From: [redacted]
Sent: 28 April 2025 16:35
To: planninginfo
Subject: DM/25/0014, DM/25/0015, DM/25/0016 and DM/25/0017

These comments follow review of the various updated documents associated with the planning application DM/25/0014 , DM/25/0015, DM/25/0016 and DM/25/0017. All planning numbers noted above are relevant for the comments below.

Re: Framework Travel Plan
https://padocs.midsussex.gov.uk/PublicAccess_Live/Document/ViewDocument?id=DD5FEE44E8634461A2A99827EC2E017F

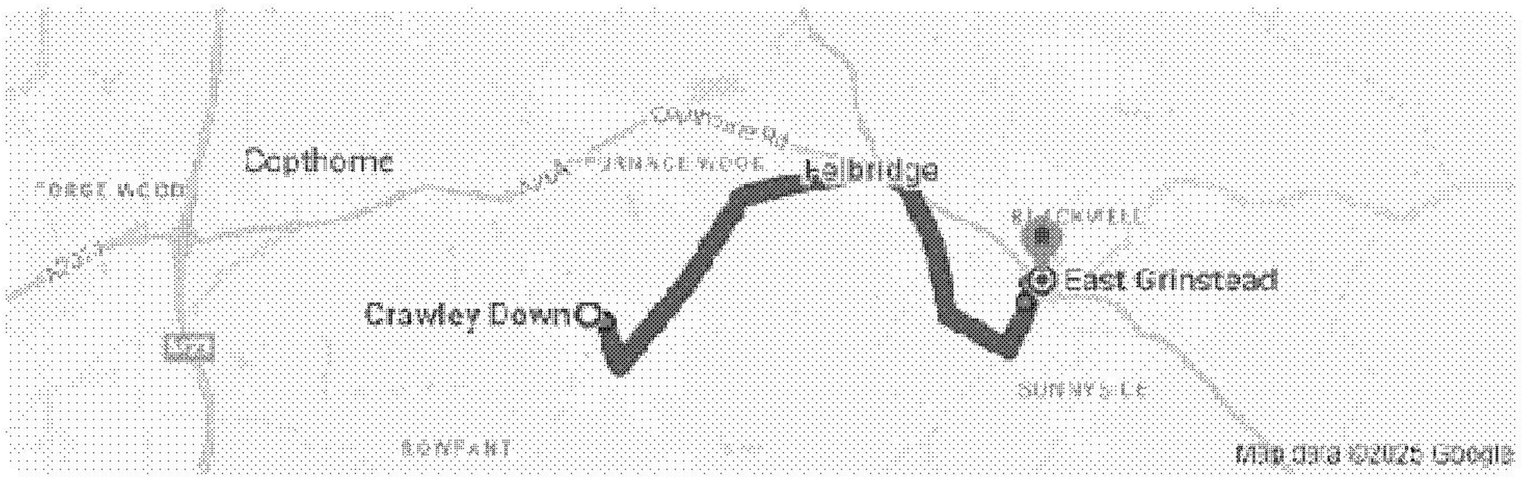
3.3.4
This section includes incorrect data;
‘journey time to East Grinstead is approximately 20 minutes’
See time estimates from bus timetables, none of which are 20 minutes. Only 1 out of 5 could be rather generously rounded down to 20 minutes, from 24 minutes.

3.3.7

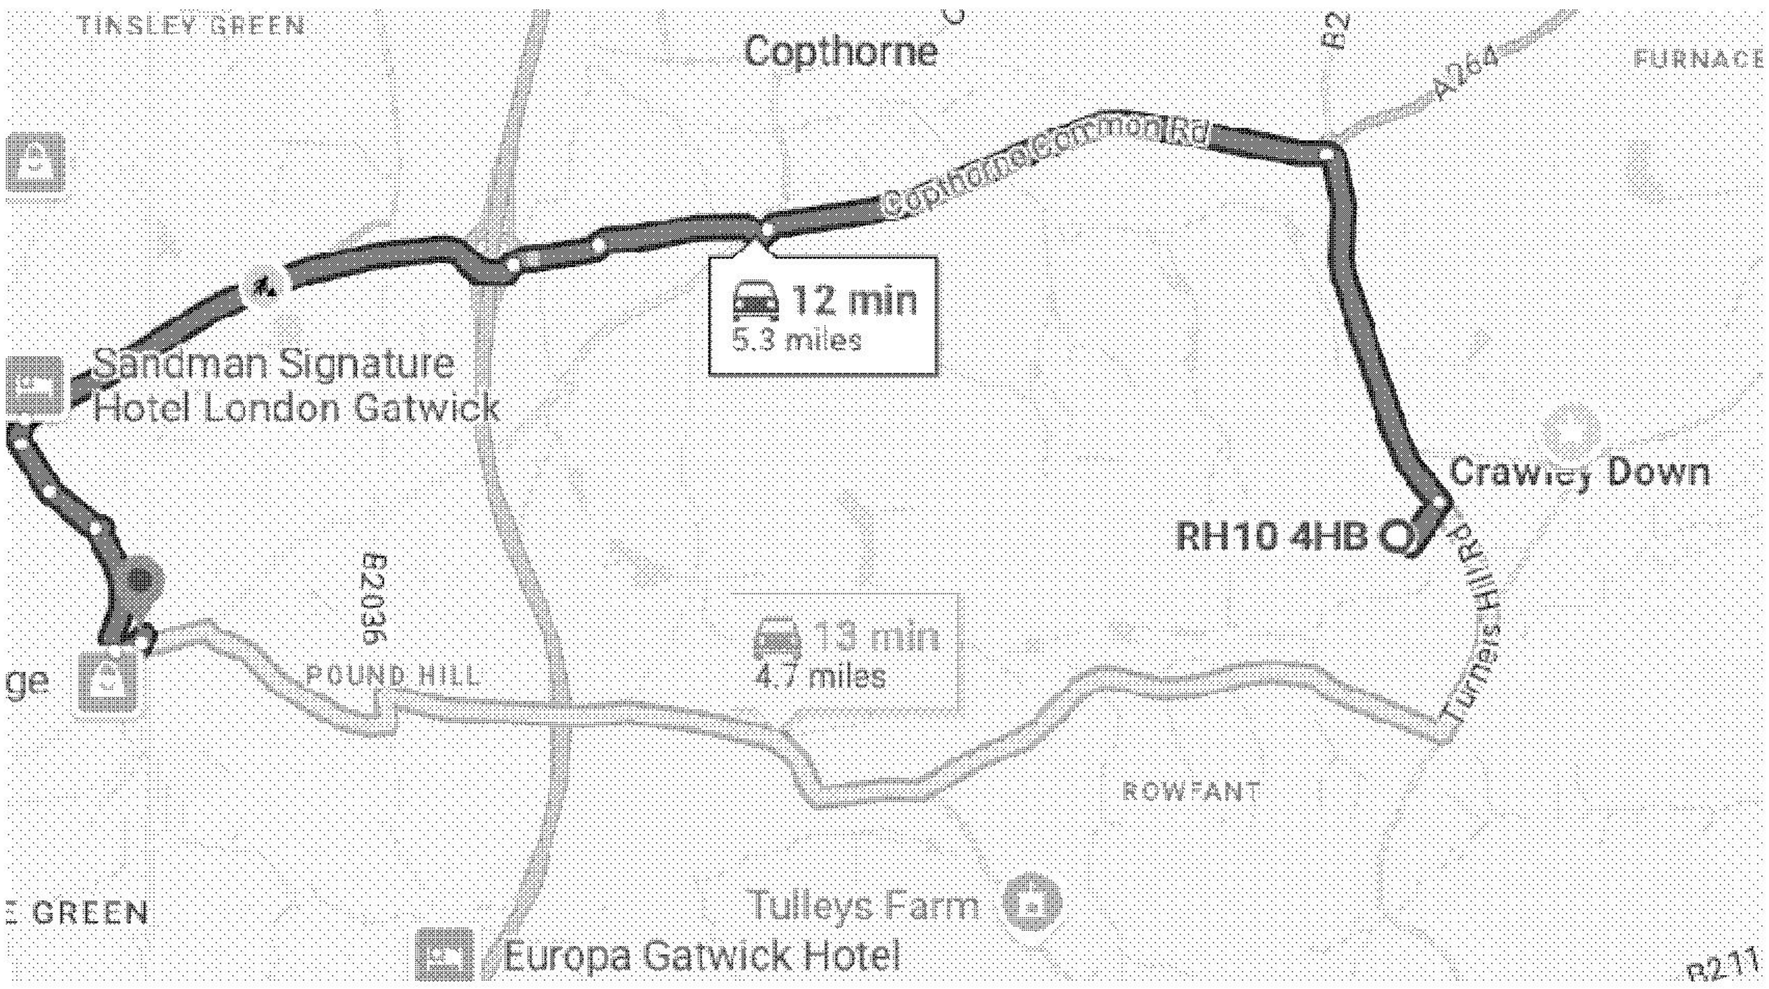
Inaccurate distances stated ‘approximately 5km to Three Bridges station’. It is in fact 7.6km (4.7miles shorter journey shown below).

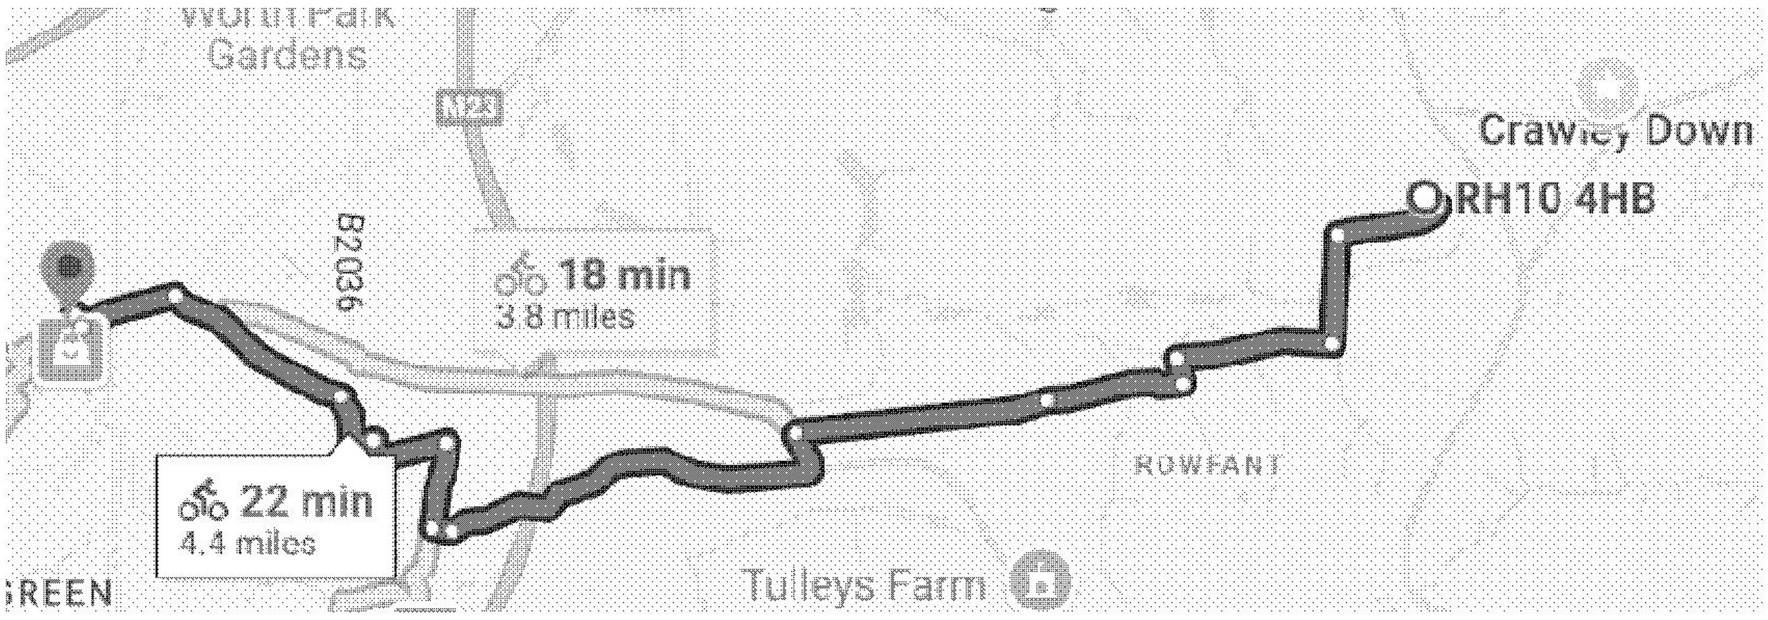
3.38
Inaccurate data claimed about cycle time to Three Bridges station:
‘’ Three Bridges and East Grinstead are accessible by bike via Worth Way (approximately a 15-minute cycle ride to Three Bridges “
See below for estimate of 22 minutes to Three Bridges along the Worth Way from Huntsland
